08 Hard Landscape Strategy: Amendment Response

Fig 15: Extract of Section 5.8 of the originally submitted Design and Access Statement - Hard Landscape Strategy - Proposed Amendment

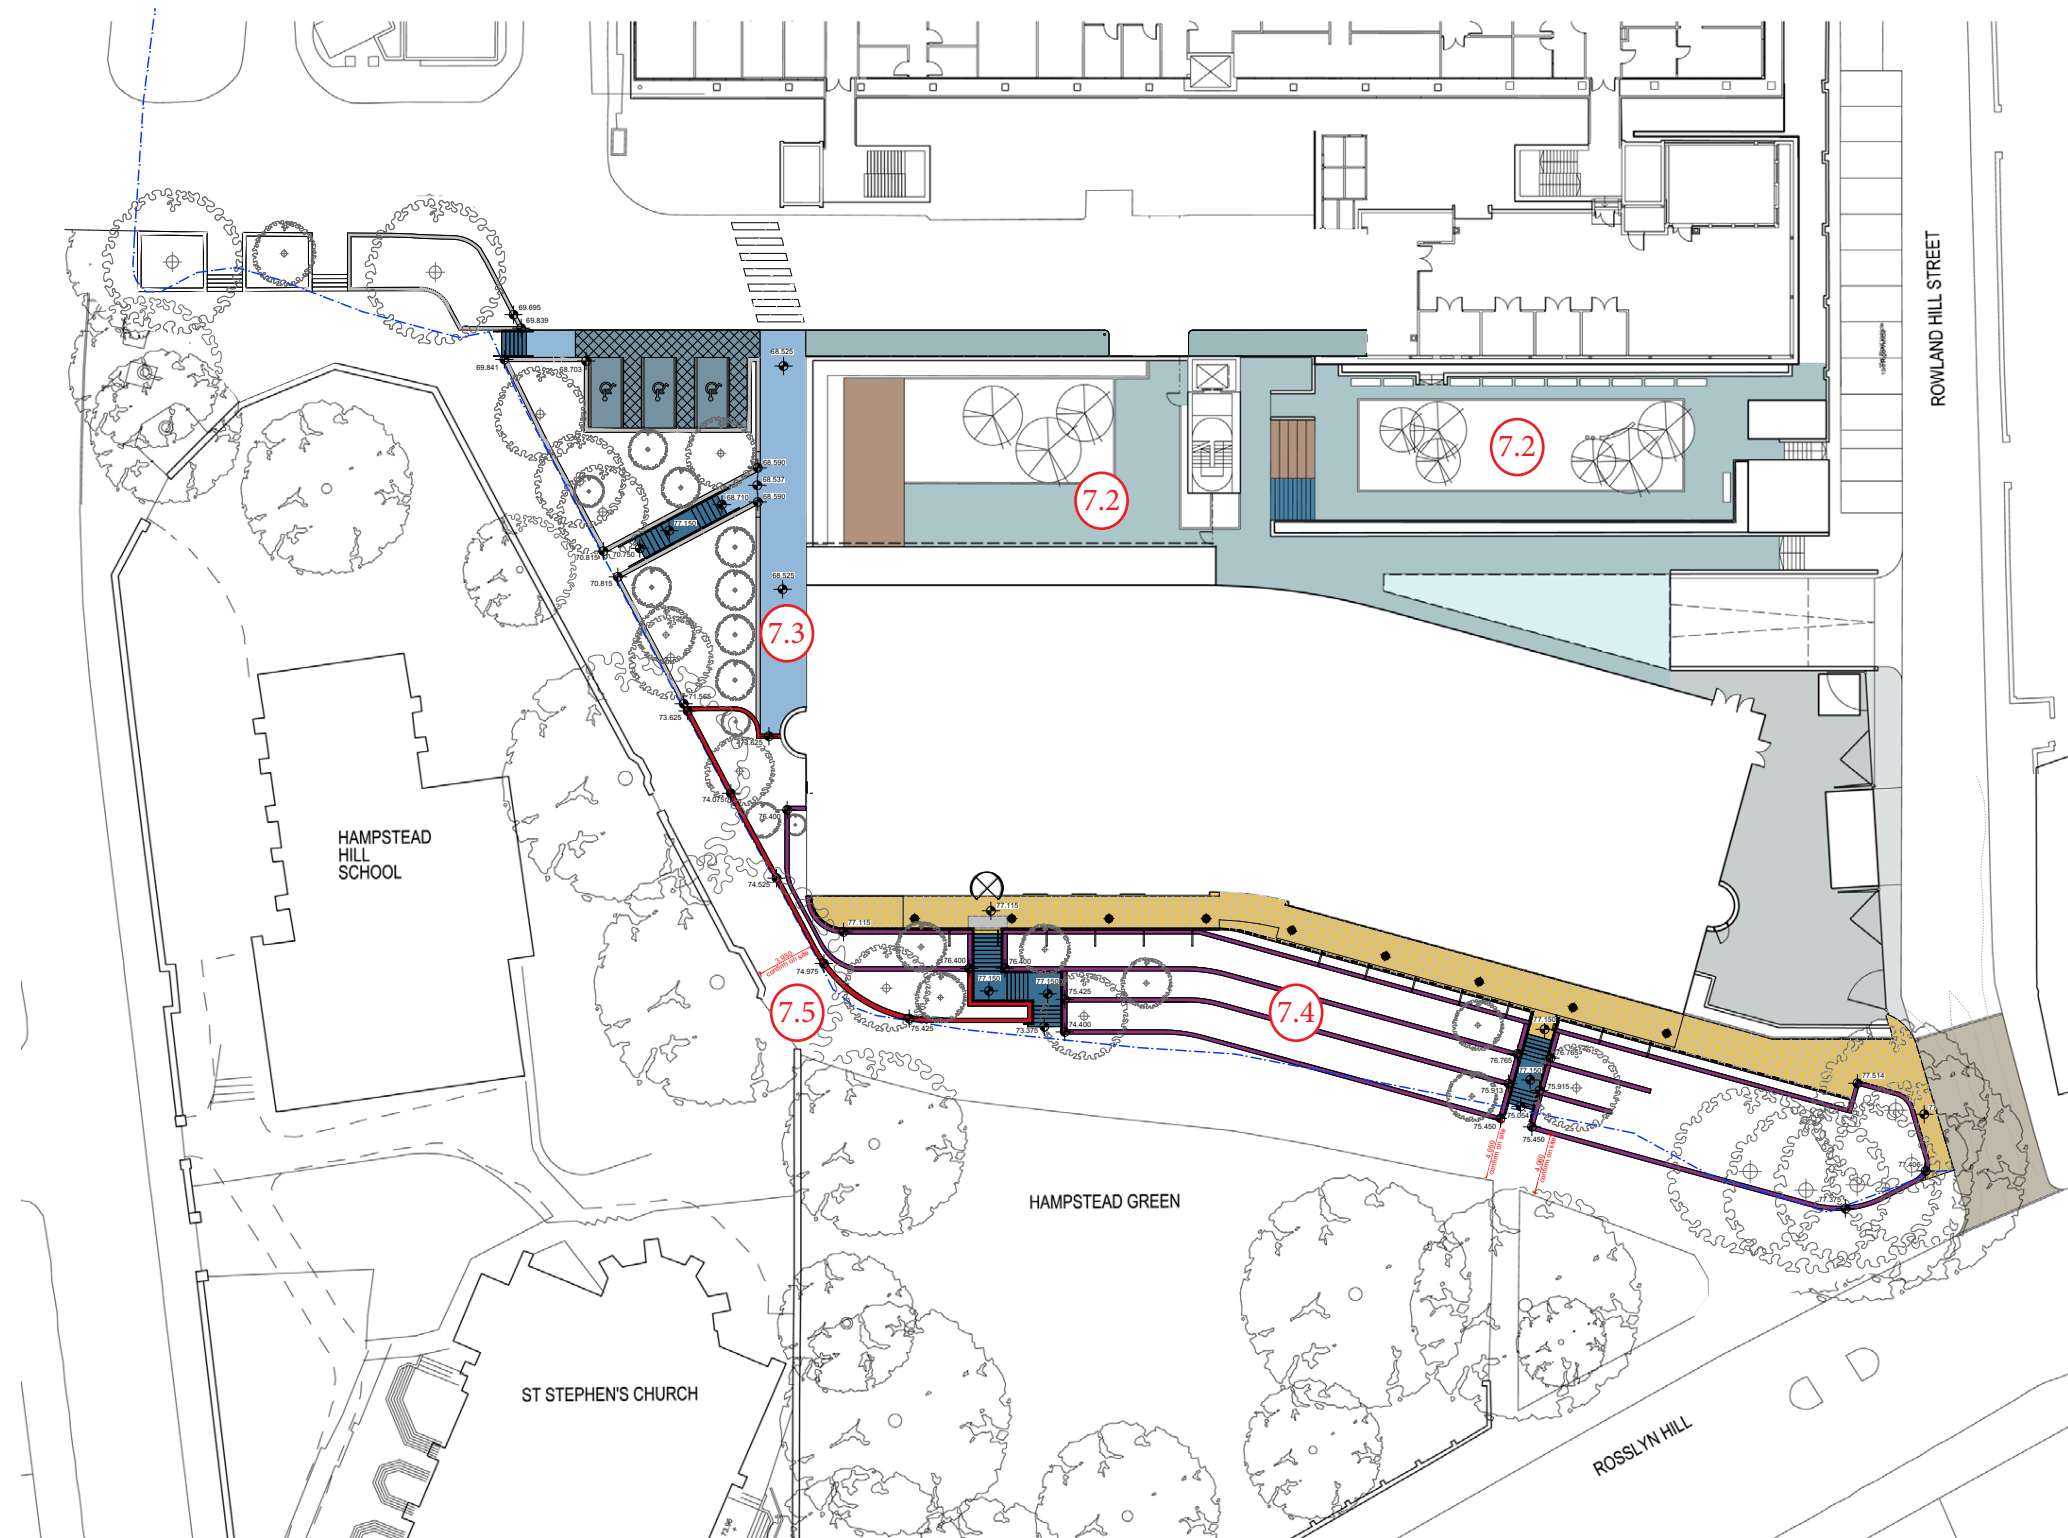
Material palette for hard landscaping retained - refer to material's key on the next page.

The UCL Garden and the Heath Strange Garden spaces to the east of the building are not part of this amendment.

North courtyard removed, but the proposed path adjacent to the North side of the building retained. The material palette for the path remains unchanged.

The two proposed car park spaces retained. The second car park space upgraded to become an accessible bay. A third accessible car park space added to the scheme in this location. The materials proposed for this area remain unchanged.

The materiality of the terraces and the aim to keep only a 150mm of the concrete visible remain unchanged. The low level terrace offering seating opportunities has been reduced to 450mm height.

The proposal to use brick on the retaining wall to the North- West corner remains unchanged in this amendment. The only changes constitutes in adding a few "steps" to the already staggered arrangement of this wall.

The proposed landscape redesign aims to return the public footpath to its existing footprint as closely as possible, maintaining the minimum existing width in all locations.
